**November 6, 2015**

02635 Version 2

## Safety Recall: Rear Grab Handle Brackets

This bulletin supersedes S/B 15-079, dated October 23, 2015, to include the Repair Procedure, Parts Information, and Warranty Claim Information

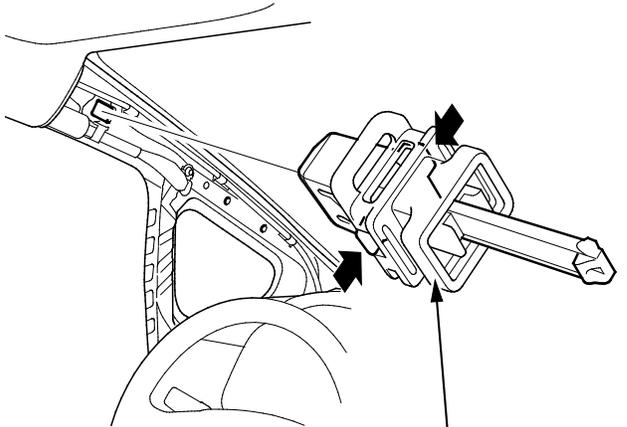
- Replace the rear grab handle brackets and torque the bolts to **4.4 N·m (3.2 lb-ft)**.

NOTE: Make sure you install the new grab handle brackets in the correct direction.

**SINGLE-TIME-USE CLIP**  
Replace.

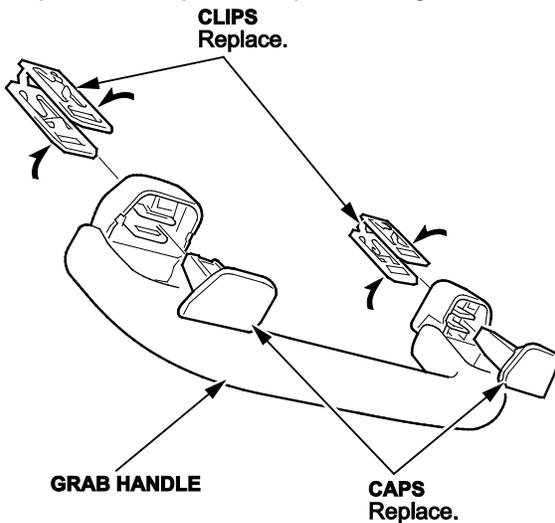
- Replace the A-pillar clips because they are a single-time-use clip.
